# IonWorks Barracuda<sup>®</sup>

Automated Patch Clamp System

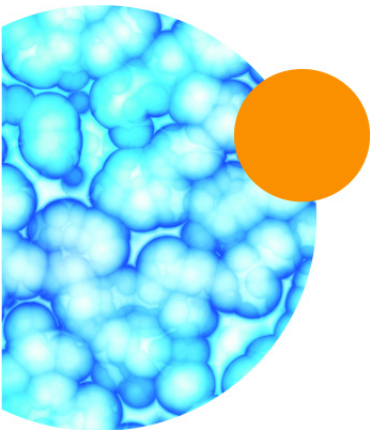
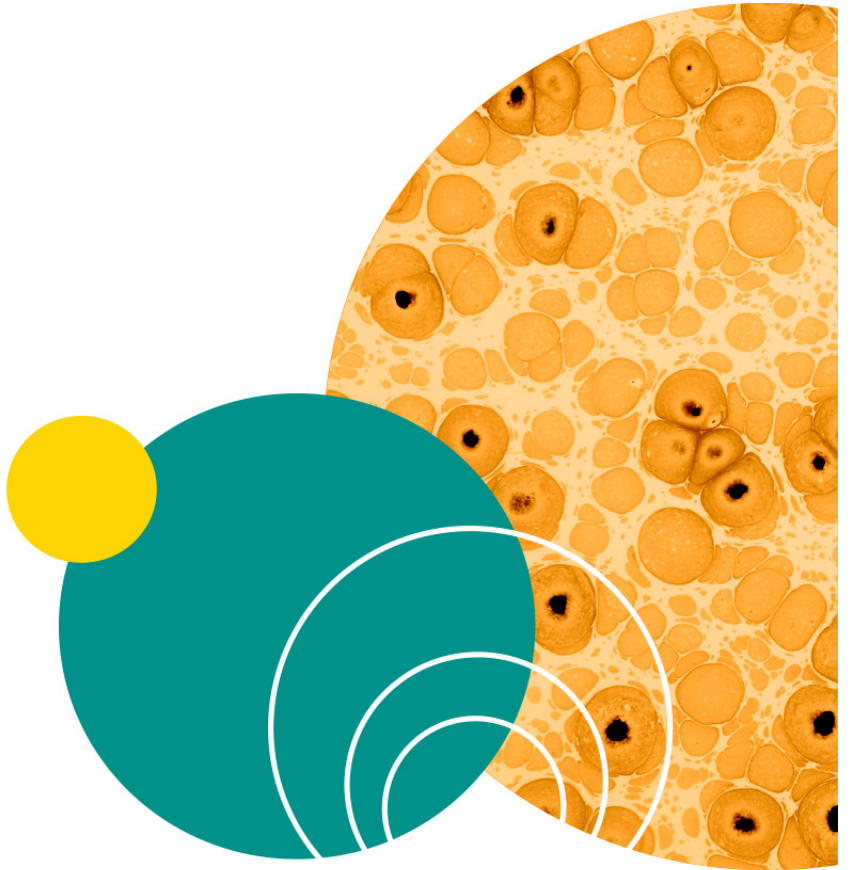
This chapter provides release notes for version 2.6 of the IonWorks Barracuda® Software. Read this entire document before you use the software. The following is a summary of the changes incorporated in this update as compared to version 2.5.4, the last general release of the IonWorks Barracuda® Software.

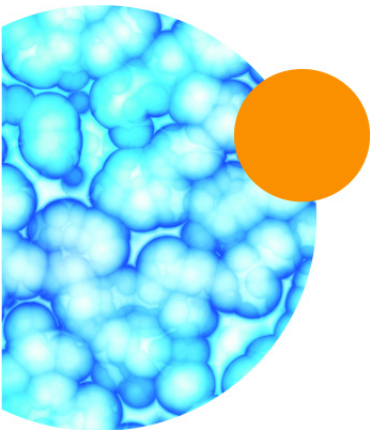
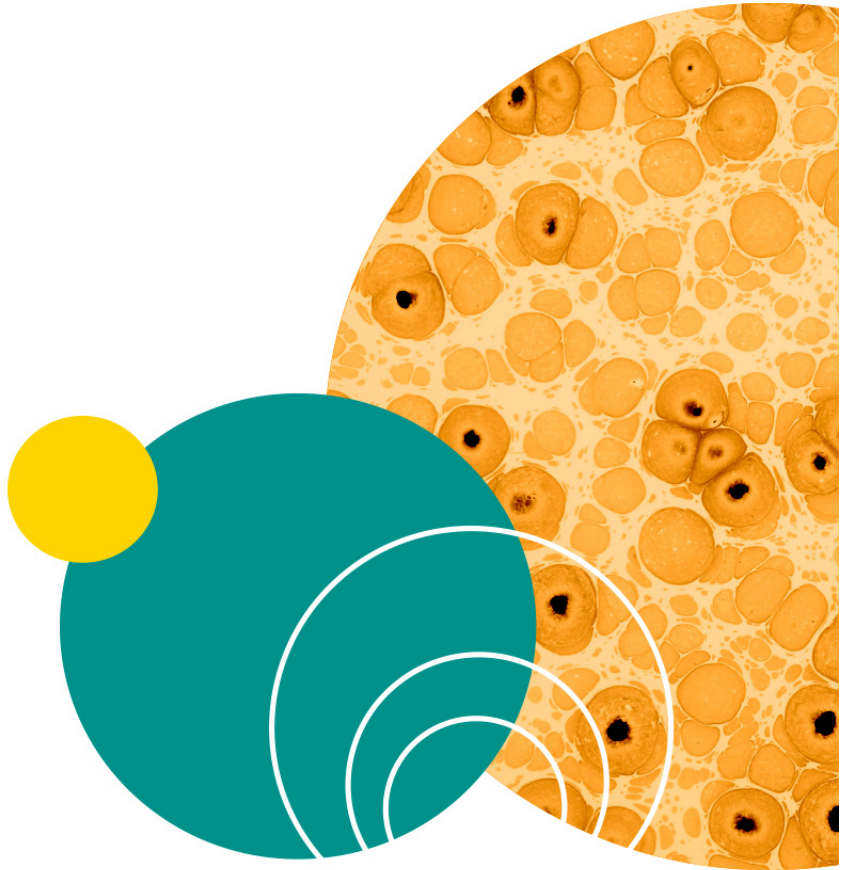
This chapter provides release notes for version 2.5.1 of the IonWorks Barracuda® Software. Read this entire document before you use the software. The following is a summary of the changes incorporated in this update as compared to version 2.5, the last general release of the IonWorks Barracuda® Software.
